Virgil C. Summer Nuclear Station (VCSNS) Units 2 and 3
Combined License Nos. NPF-93 and NPF-94
Docket Nos. 52-027 & 52-028

Subject: LAR 13-09 R1 S1 License Amendment and Exemption Request: Annex and Radwaste Building Changes

**SCE&G Response to Supplemental NRC RAI Question
(LAR 13-09 R1 S1)**

Figure 9.4.8-1

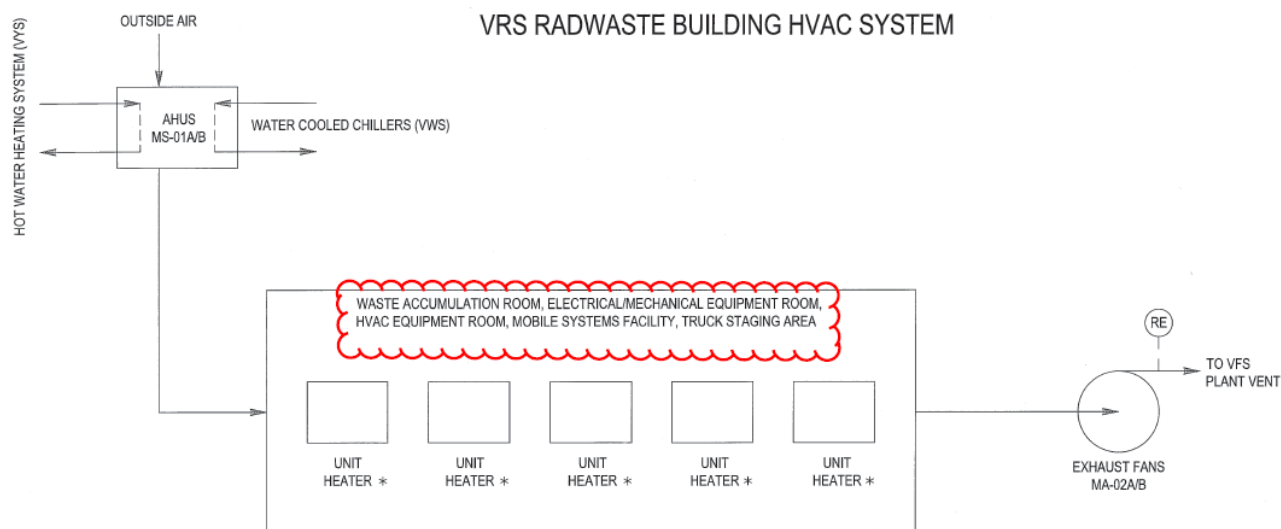
UFSAR Figure 9.4.8-1, *Radwaste Building HVAC System* (Changes shown on latest Figure per UFSAR Rev. 3)
